ADDENDUM #2

Project: Phase #2 of Finish Renovations at
John Wood Elementary School.
6100 East 73rd Ave
Merrillville, Indiana 46410
Architect's Project #25058

This addendum forms a part of the Bid Documents and modifies the original Bid Documents dated 1/29/2026 as noted below. Acknowledge receipt of this addendum in the space on the Bid Form. Failure to do so may subject bidder to disqualification.

SHEET
A
1.1.1

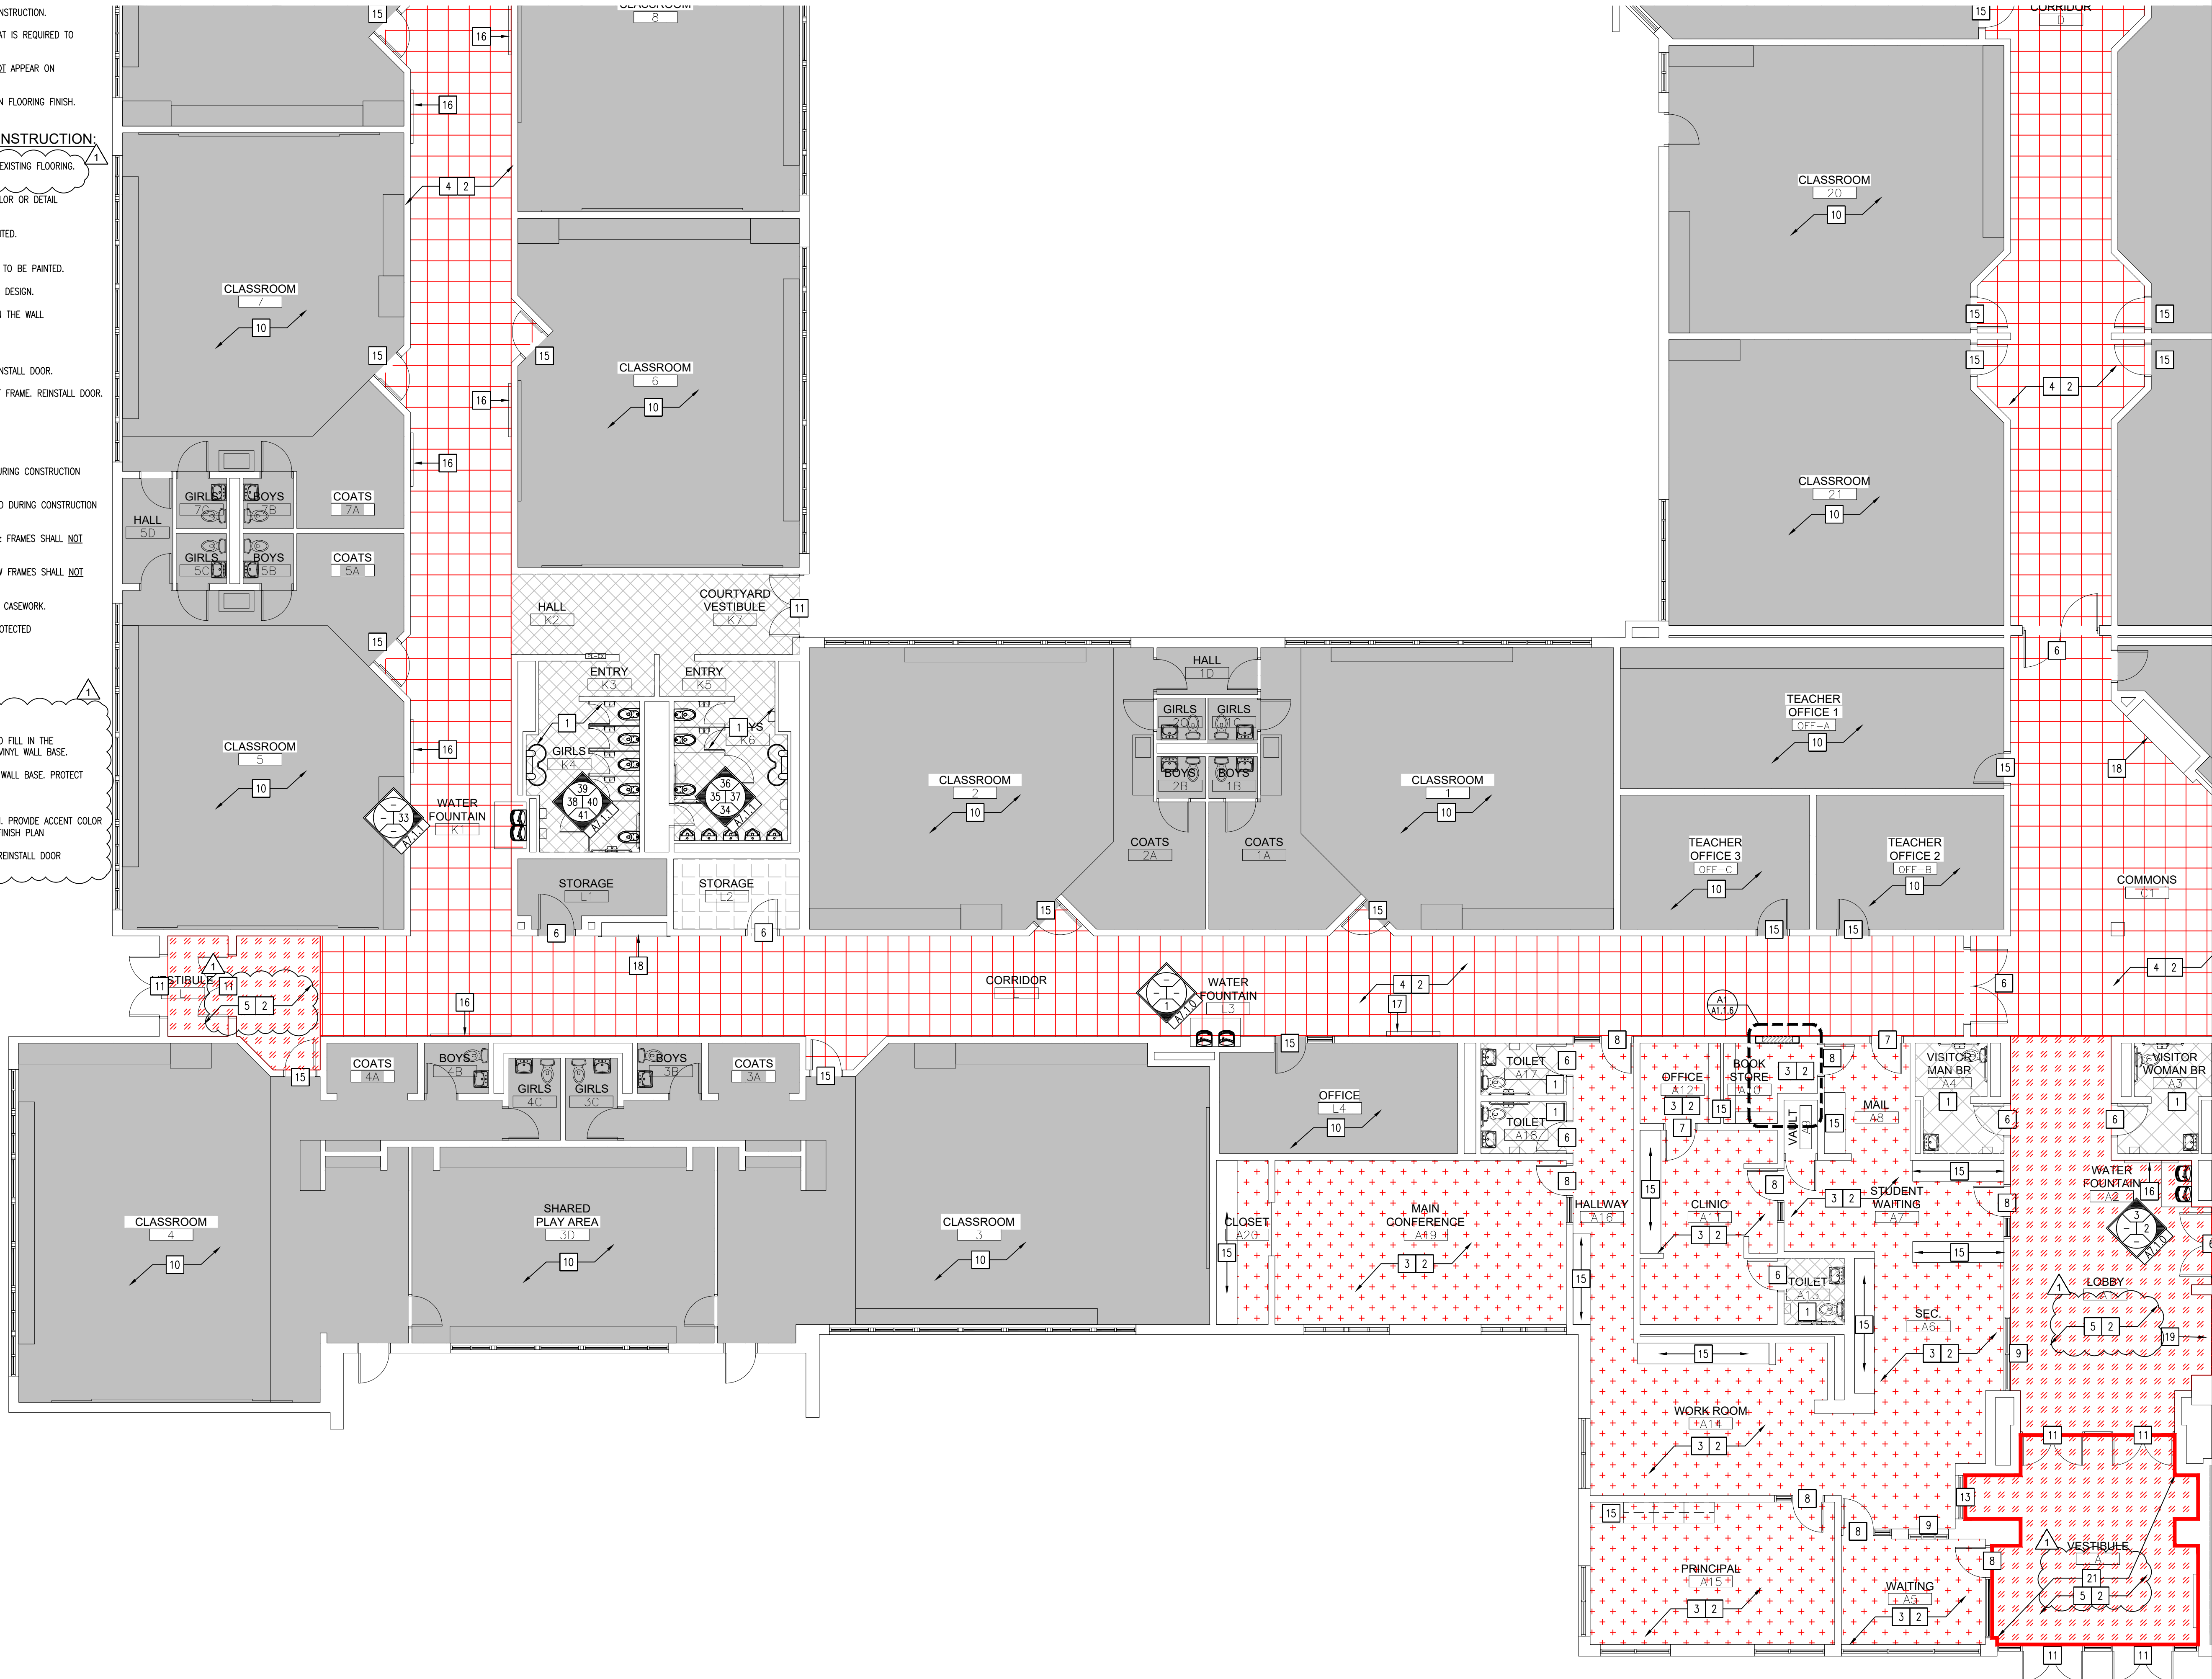
9. See attached Revised Drawing Sheet A1.1.1 – Partial Floor Plan – Area A – New Construction - This plan shows clouded and tagged revisions dated 02-17-2026.

SHEET
A
1.1.2

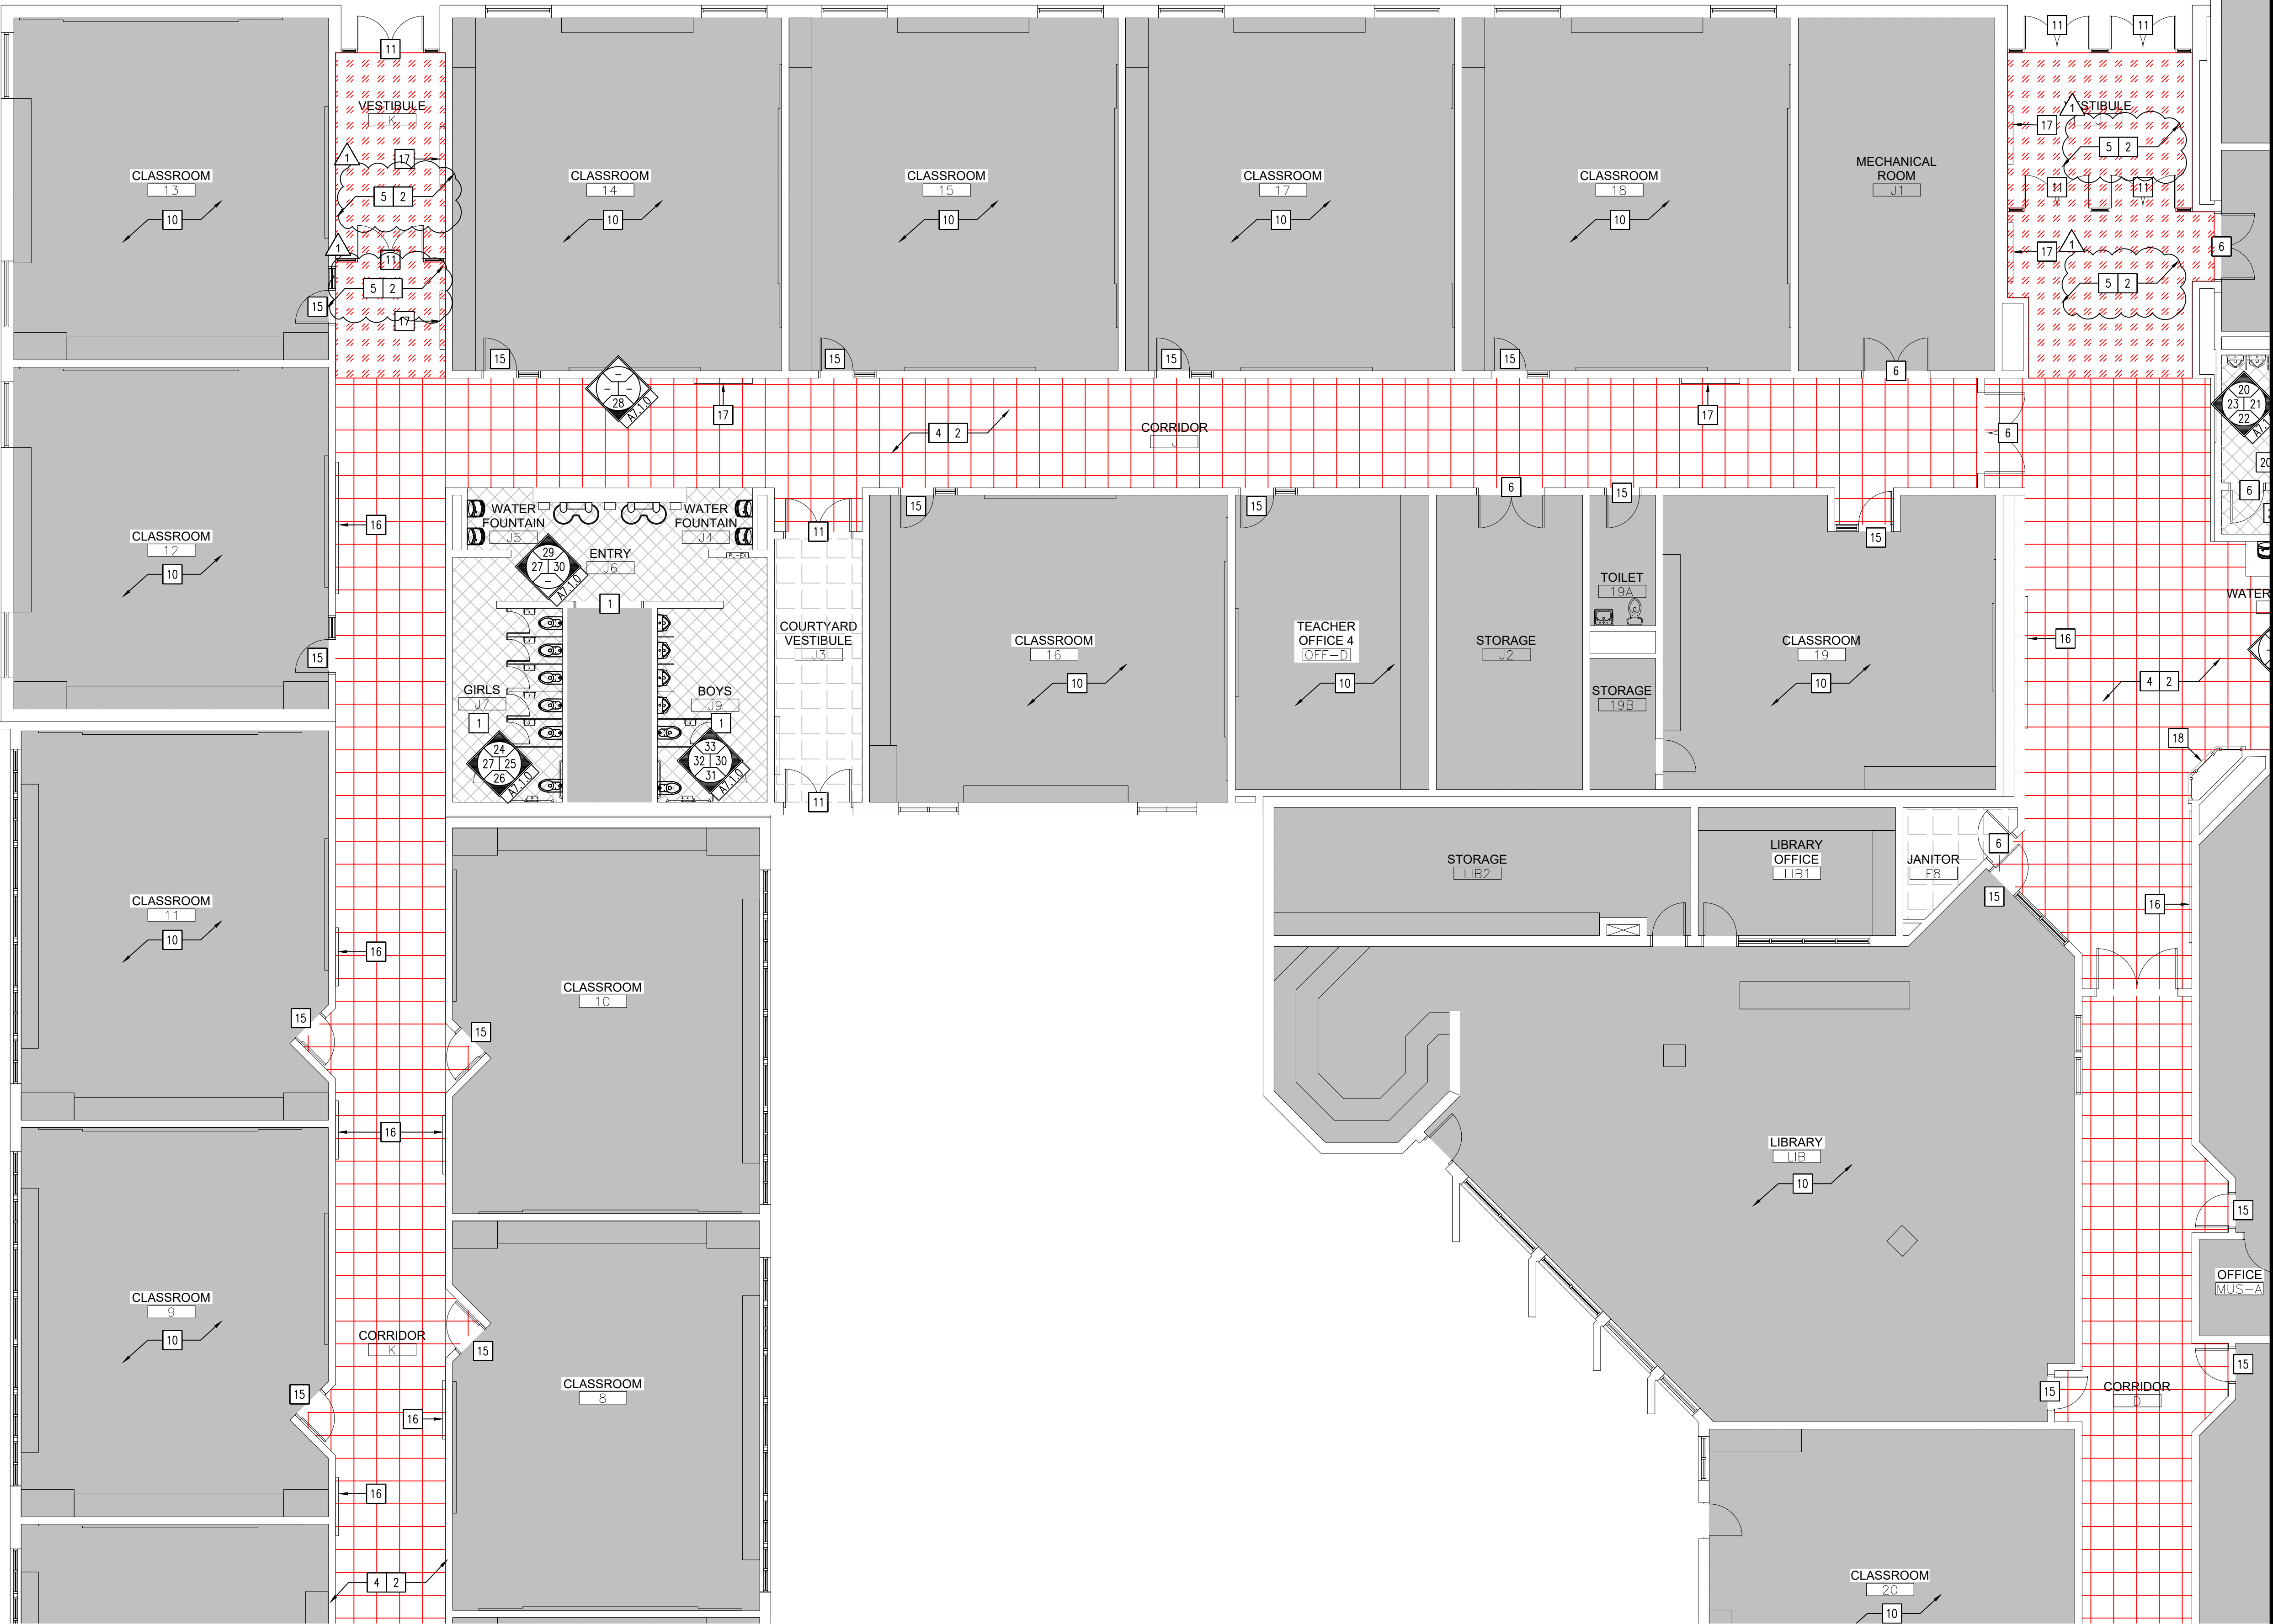
10. See attached Revised Drawing Sheet A1.1.2 – _Partial Floor Plan – Area B – New Construction - This plan shows clouded and tagged revisions dated 02-17-2026.

SHEET
A
1.1.3

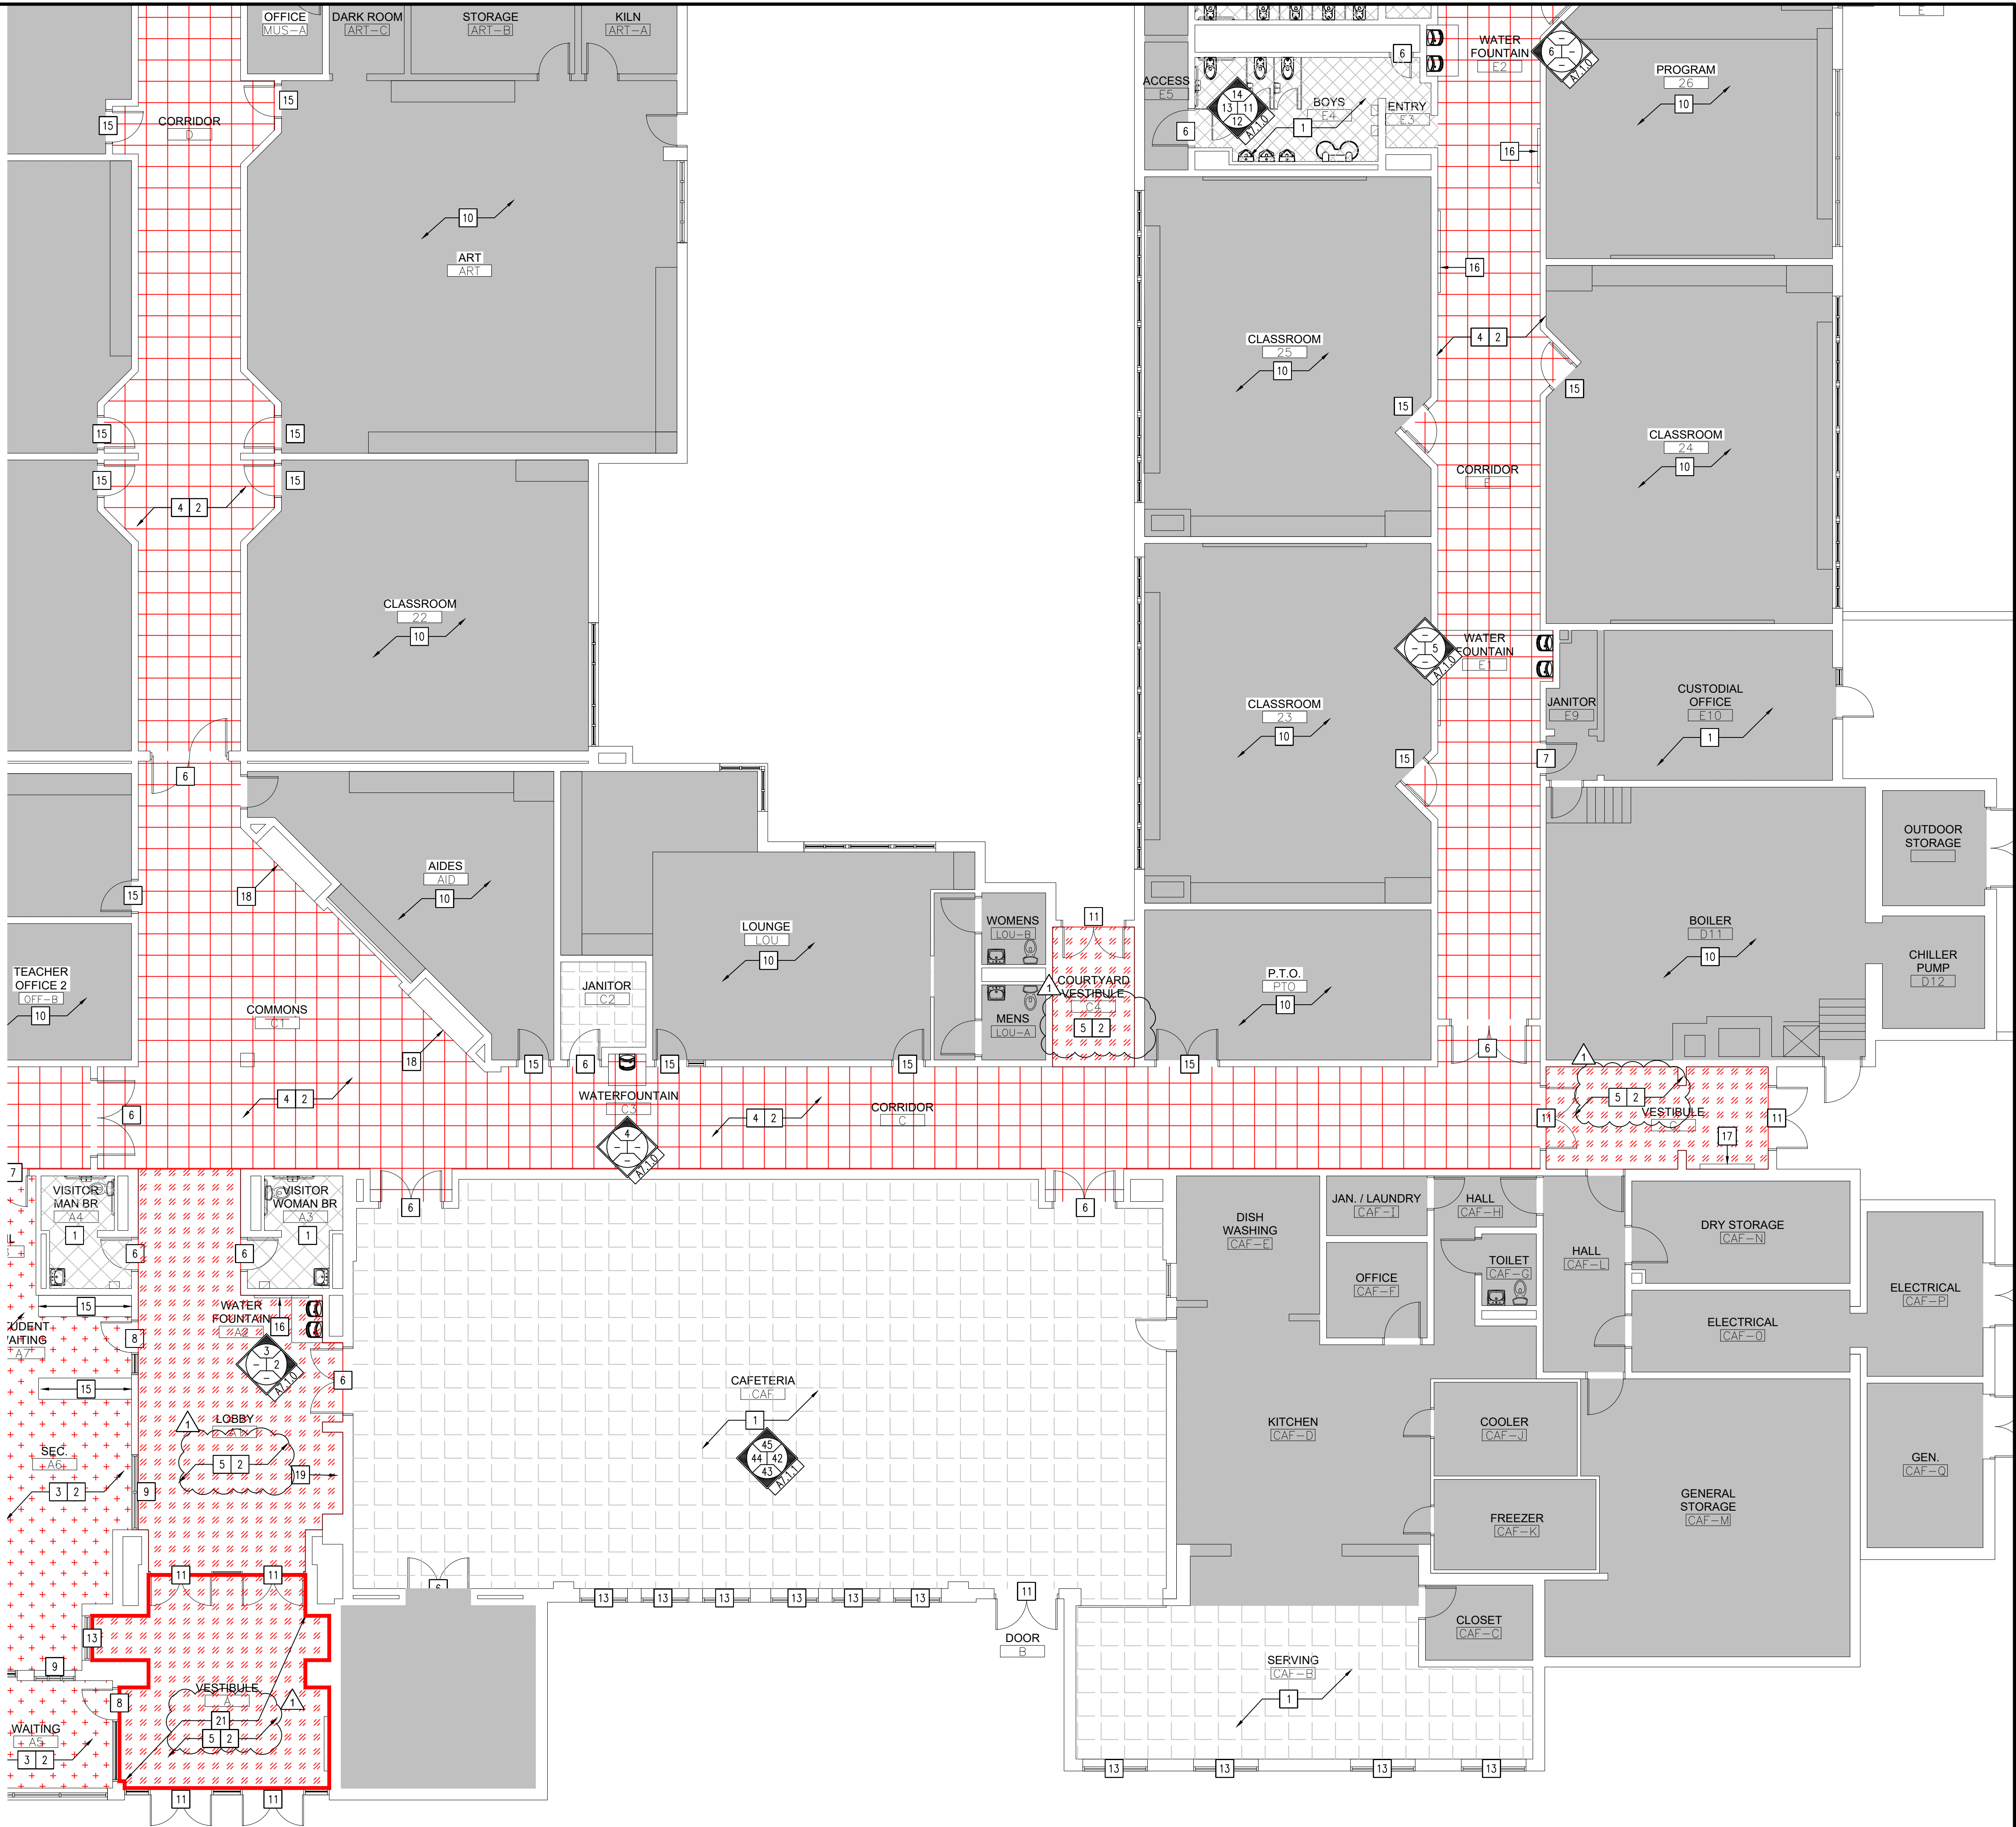
11. See attached Revised Drawing Sheet A1.1.3 – _Partial Floor Plan – Area C – New Construction - This plan shows clouded and tagged revisions dated 02-17-2026
